MITIGATION PLAN

**Hip Bone Creek Restoration Site
Chatham County, North Carolina
DMS Project Number 100059
DMS Contract 7528
USACE AID #: SAW 2018-01160
DWR #: 2018-0785**

Subject: Hip Bone Creek Restoration Site
Mitigation Plan Review – Response to IRT Comments
Cape Fear River Basin - 03030003
Chatham County, North Carolina
DEQ Contract No. #7528
DMS Project #100059
USACE AID #: SAW-2018-01160

**FIGURE 9. PROPOSED MONITORING
HIP BONE CREEK RESTORATION SITE
CHATHAM COUNTY, NC**

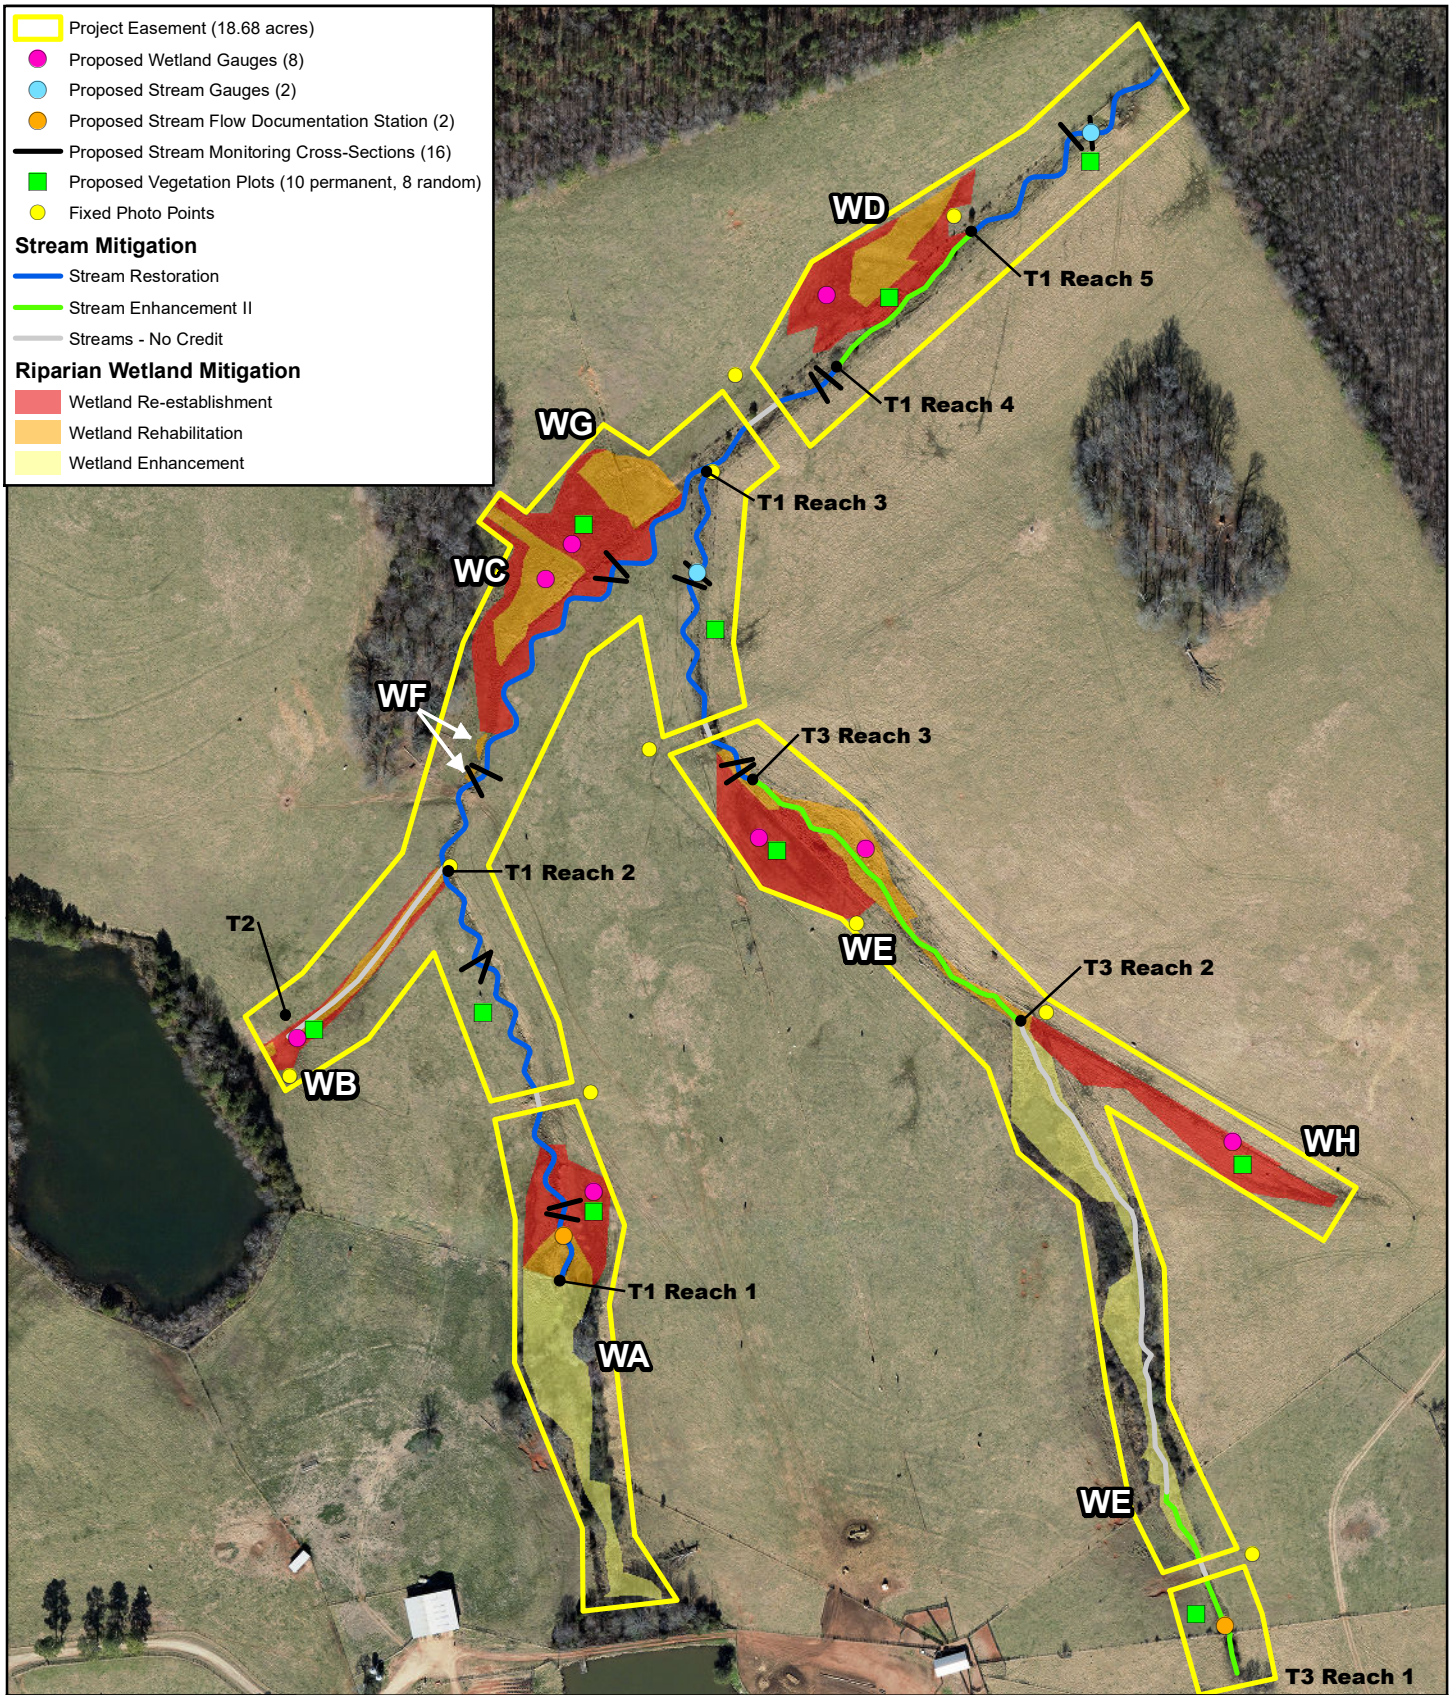
19. Figure 9 – The flow documentation stations on T3 and T1 are very close to the stream reach start points. DWR requests these stations be shifted north approximately 50-75 feet.

13. Page 32: Please depict fixed photo points on Figure 9.

The flow stations have been moved 50 feet north on Figure 9.

Fixed Photo Points have been added to Figure 9.

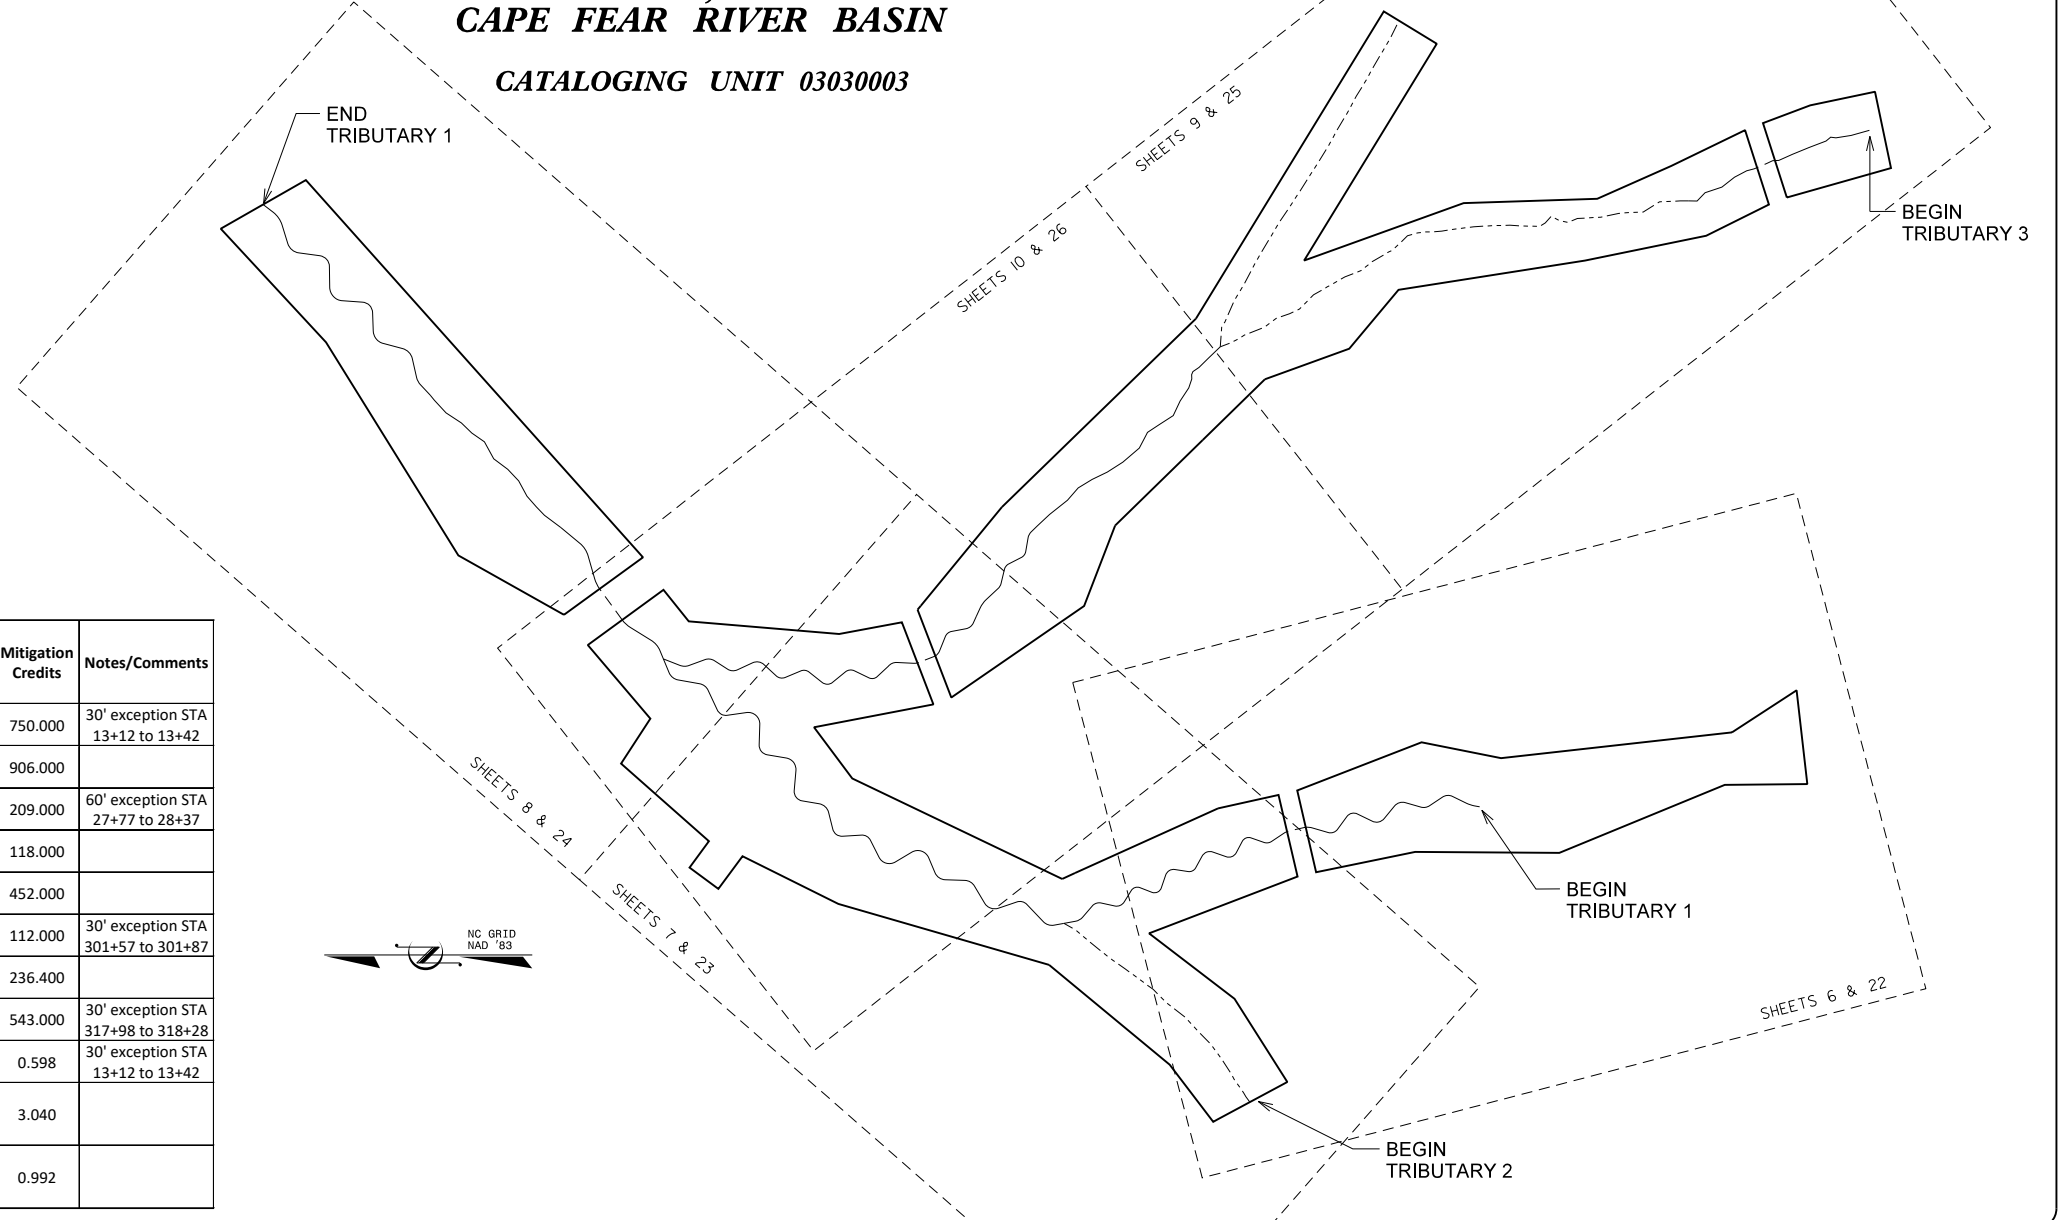
20. Sheet 1 – The Sheet 1 table does not match the Table 11 values under the Existing Footage/Acreage and Mitigation Credits columns. Please update.

We adjusted the significant digits in a previous draft of the report and have now made sure Sheet 1 matches the report.

SHEET 5A OF 26

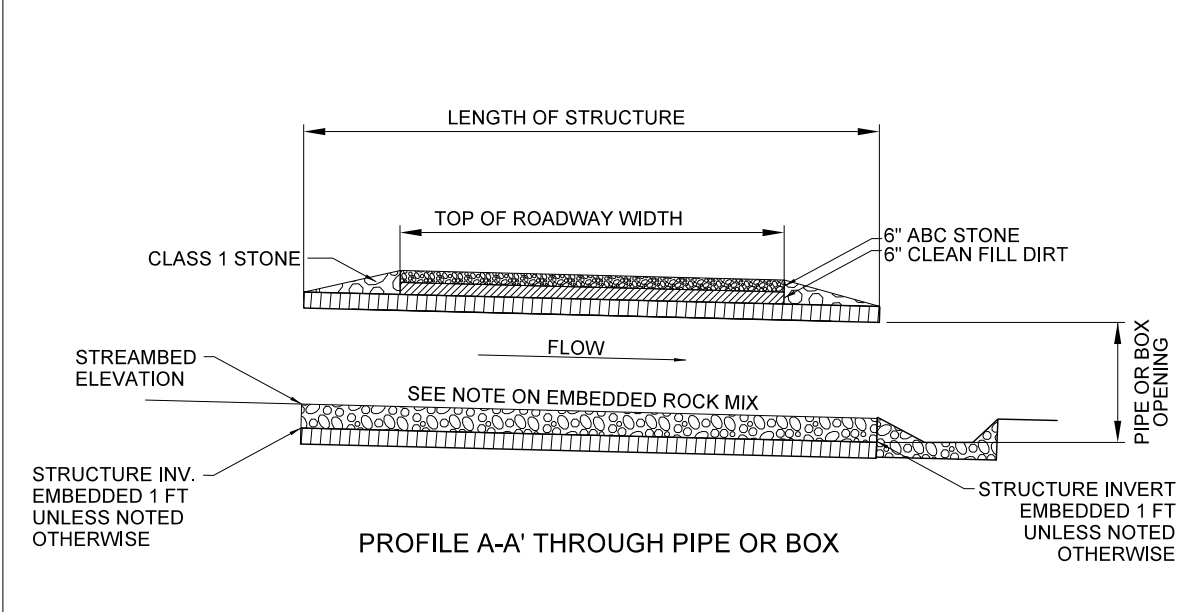
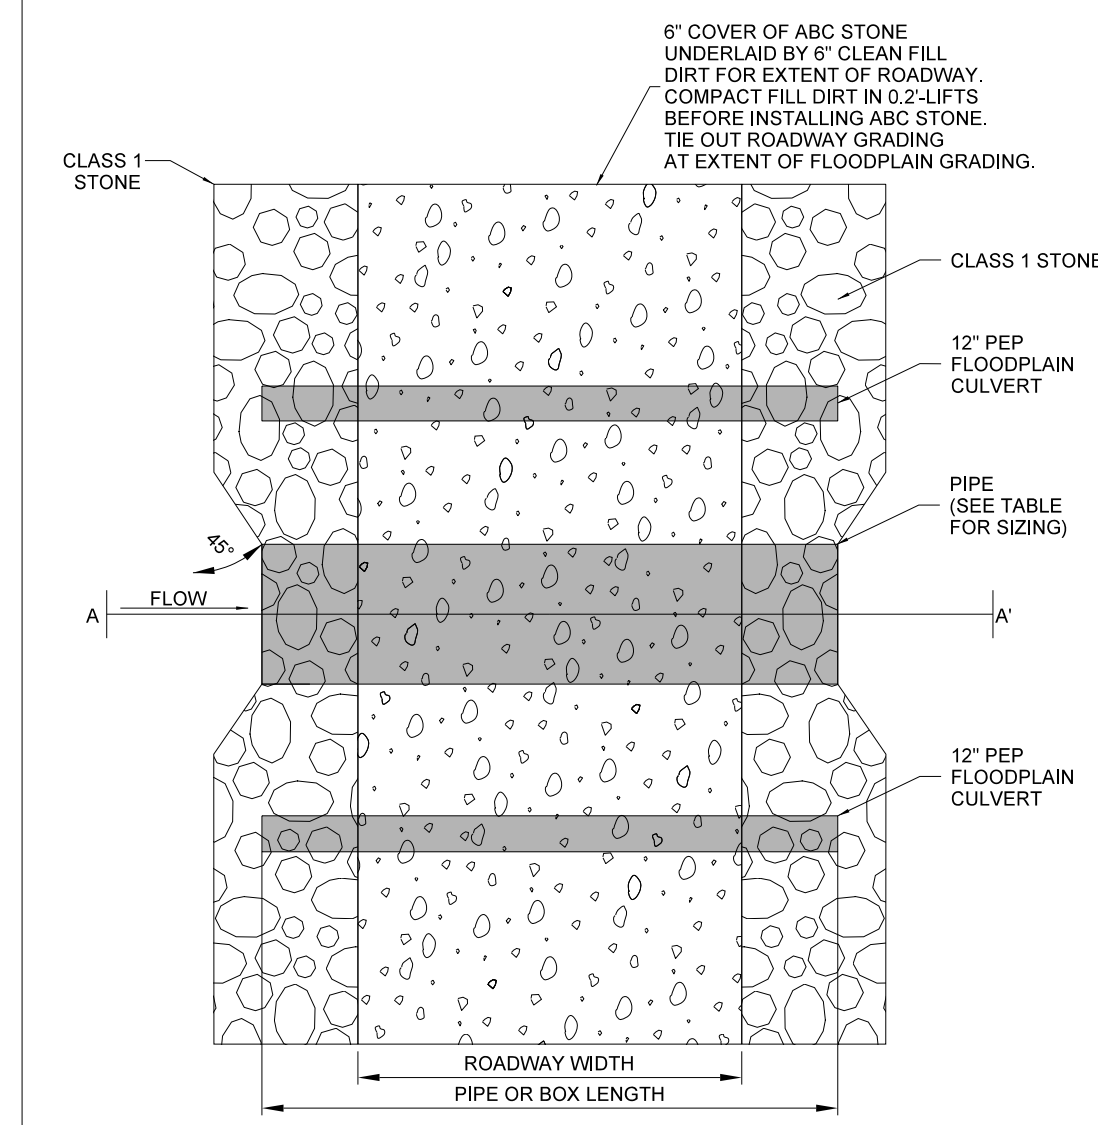
23. Sheet 4 – Please add a culvert crossing detail.

A culvert sheet (Sheet 5A) has been added with details for the structures.
